Guaranteed Energy Savings Project Buchanan Community Schools 2022

Addendum No. 2

OTTAWA ELEM. MECHANICAL PLAN

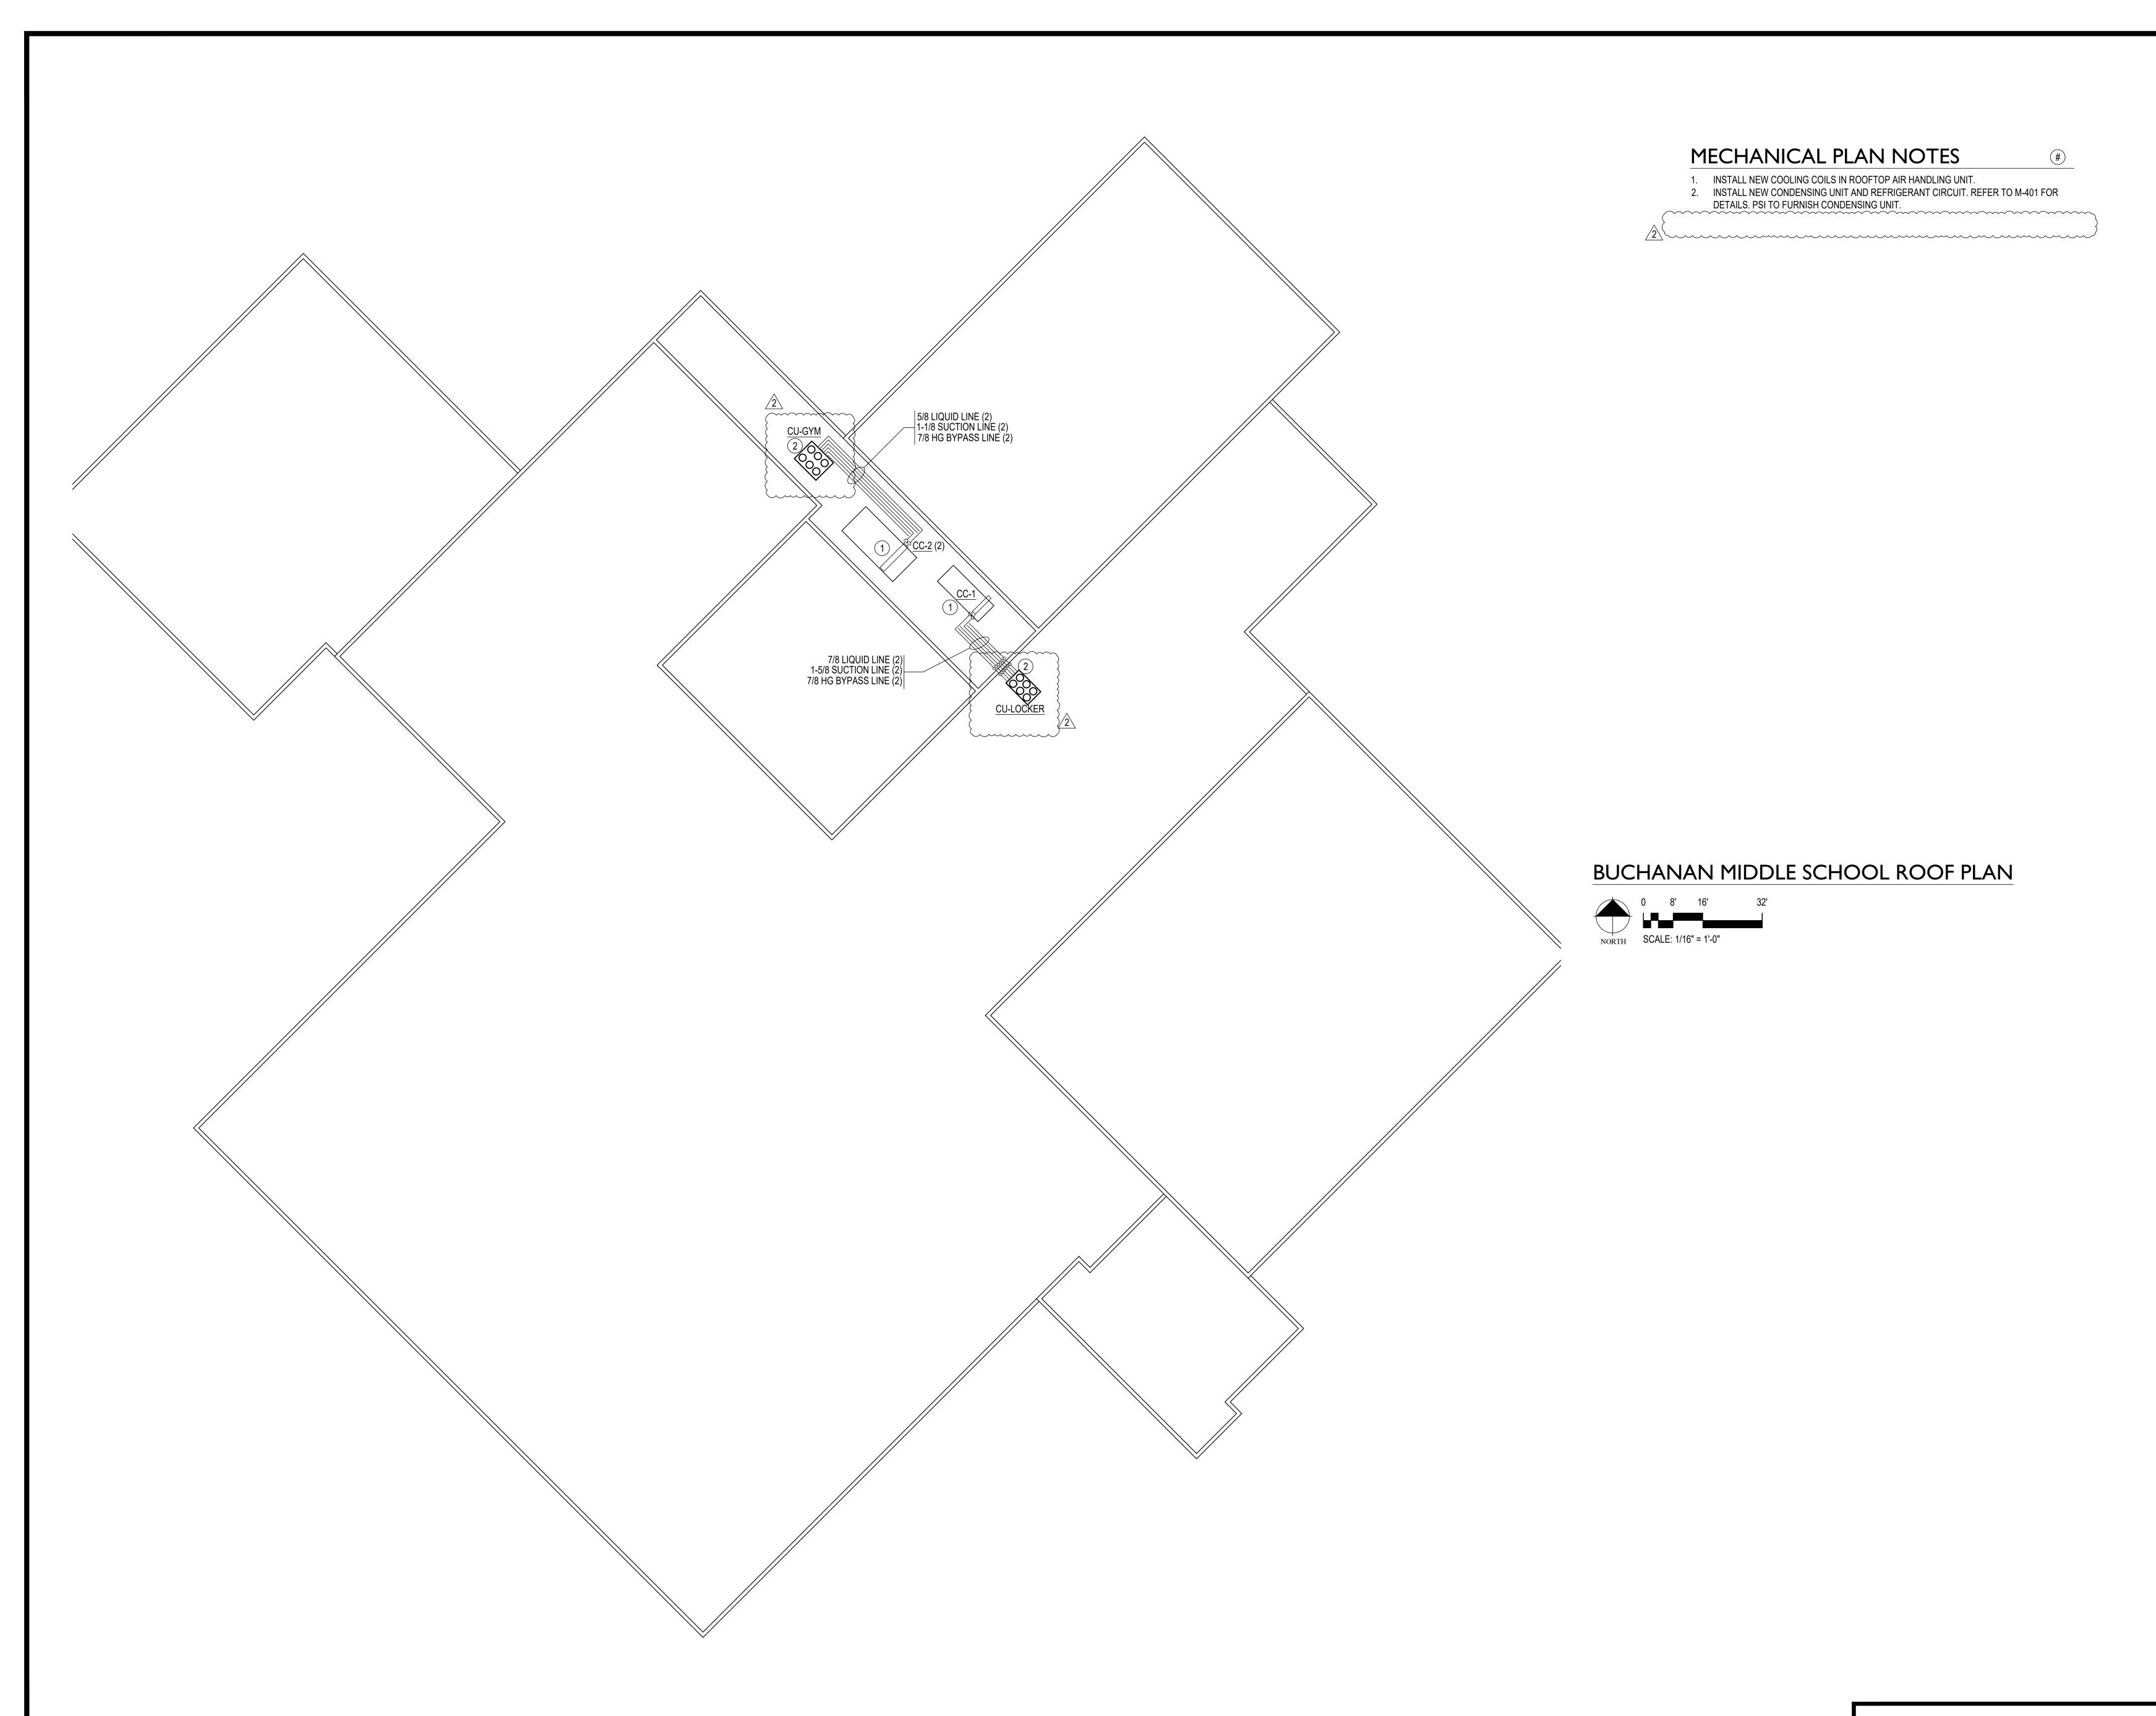
- 1) Sheet M-201
 - a) See revised Mechanical Plan Note 6.
 - b) See clouded area affected by Note 6.
 - c) See added BCU-02 Diagram.
- 2) Sheet M-202
 - a) See removed Mechanical Plan Note 3.
 - b) See clouded area where Note 3 is removed.
- 3) Sheet M-501
 - a) See revised Blower Coil Unit Schedule note 4.
 - b) See revised Air Cooled Condensing Unit Ottawa Elementary.
 - c) See revised Variable Frequency Drive Schedule HP requirements.
 - d) See added detail 1 AHU Coil 3-Way Valve Piping.

6. INSTALL NEW BCU-2 (MEDIA CENTER) IN SIMILAR LOCATION TO THE EXISTING AHU.
 PROVIDE MIXING BOX BELOW UNIT WITH FRONT RETURN AIR AND BACK OUTSIDE AIR
 CONNECTIONS. MOUNT MIXING DAMPERS FURNISHED BY PSI. INSTALL NEW ACCU ON
 ROOF ABOVE. PROVIDE AND INSTALL NEW REFRIGERANT PIPING AND SPECIALTIES
- 7. INSTALL NEW RELIEF FAN ON EXISTING CURB. SUBCONTRACTOR SHALL PROVIDE CURB ADAPTOR. VERIFY SIZE OF EXISTING 32"x32" CURB. REFER TO M-400 SHEETS FOR DETAILS. PSI TO FURNISH FAN.
